Some issue of $p\bar{b}$ trap

Antiproton line with trap
Cage organisation

TM 10 Dec 2019 JYR

Possible effects by spark at accelerator

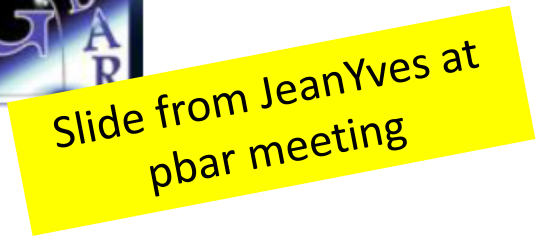
- Damage to PXI or compactRIO channel
 - Break the module
 - Give effect to the action of control
- Better to have extra relay?
- Have some monitoring of the current for example.

About the electron gun at CF160 cross

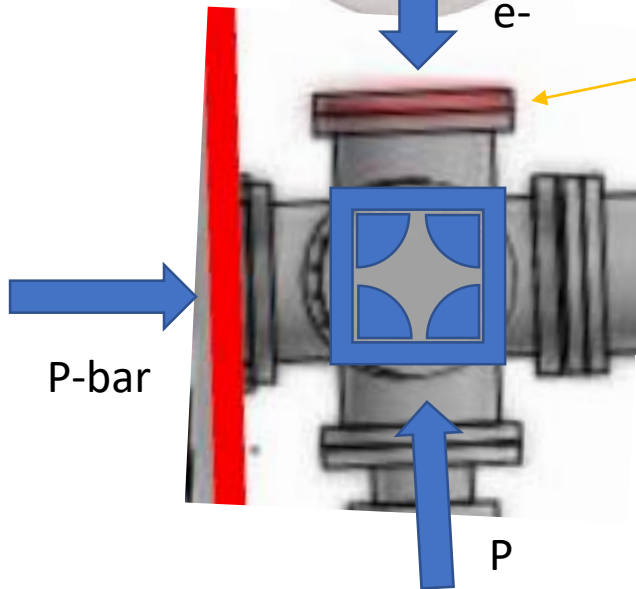
- Issue to care : If p beam hits the electron cathod, it may be damaged. → gate valve required?
- If so, we need separated pumping system in the electron cathode part :(minimum requirement) gate valve + Reducer(CF160->100) + T (CF100) + valve (CF100)
- Need to be careful to use the HV floated cathode (spark issue)
